SUBJECT: Responds to 881208 request re design of automatic depressurization sys design.

MONTICELLO NUCLEAR GENERATING PLANT
DOCKET NO. 50-263 LICENSE NO. DPR-22

AUTOMATIC DEPRESSURIZATION SYSTEM DESIGN

FIGURE 1

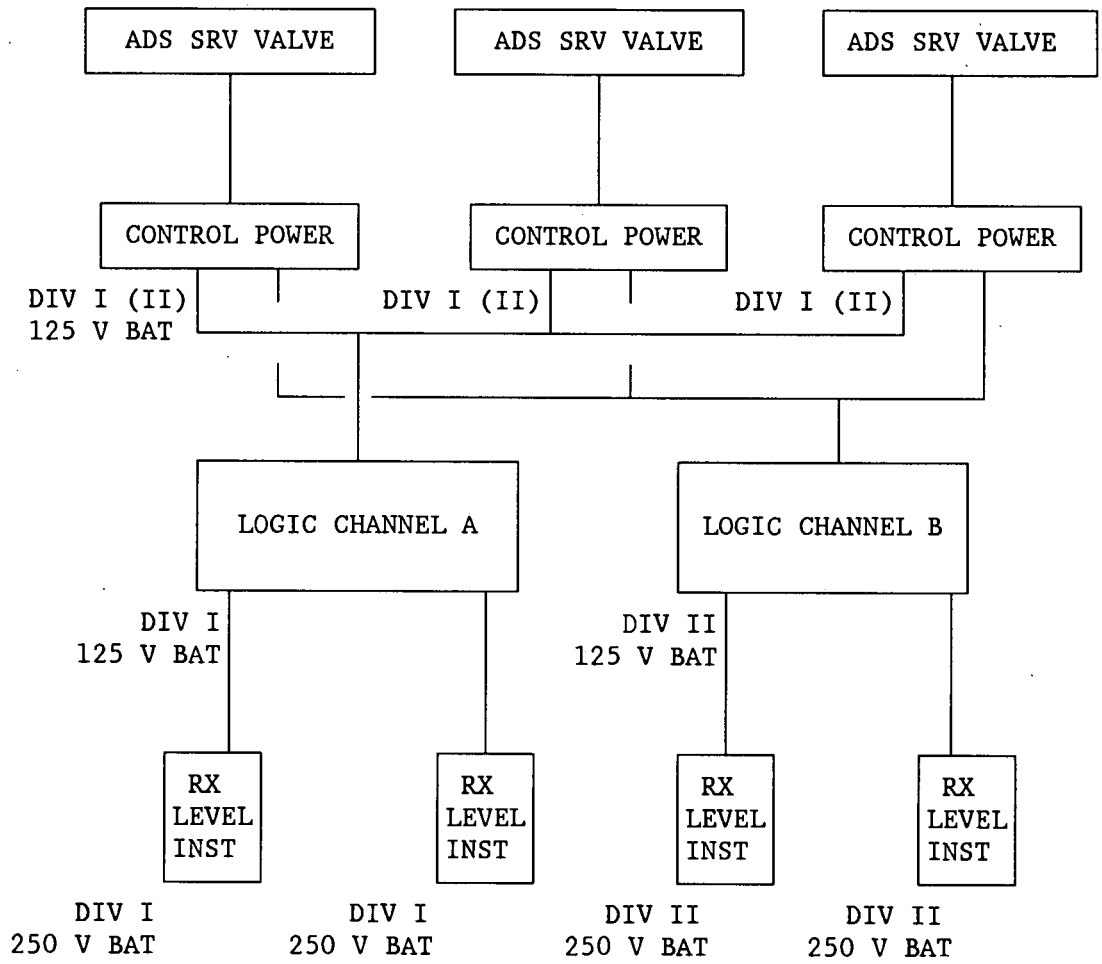
Automatic Depressurization System (ADS) power supplies are shown in Figure 1. All power sources are from the 125 VDC or 250 VDC Batteries. There are two 125 VDC batteries, Division I and Division II. There are also two 250 VDC batteries, Division I and Division II. The 250 VDC batteries have center taps so that 125 VDC loads can be supplied from the 250 VDC batteries. All of the ADS loads are 125 VDC. Loss of any one of these four power supplies will not disable the ADS system.

The loss of Division I 125 VDC battery will disable the Channel A logic and cause the control power for the valves to shift to the Division II 125 VDC battery. Since the valves have control power and the Channel B logic and instruments have power, ADS will function properly.

Loss of Division II 125 VDC battery will disable the Channel B logic and the backup control power for the valves. Since the valves have control power from Division I and the Channel A logic and instruments have power, ADS will function properly.

Loss of Division I 250 VDC battery will disable the reactor level instruments that supply level information to Channel A. Since the valves have control power and the Channel B logic and instruments are fully operable, ADS will function properly.

Loss of Division II 250 VDC battery will disable the reactor level instruments that supply level information to Channel B. Since the valves have control power and the Channel A logic and instruments are fully operable, ADS will function properly.

If one SRV should fail, the Automatic Depressurization System function would still be available because only two of the three safety relief valves are necessary for the system to fulfill its function.
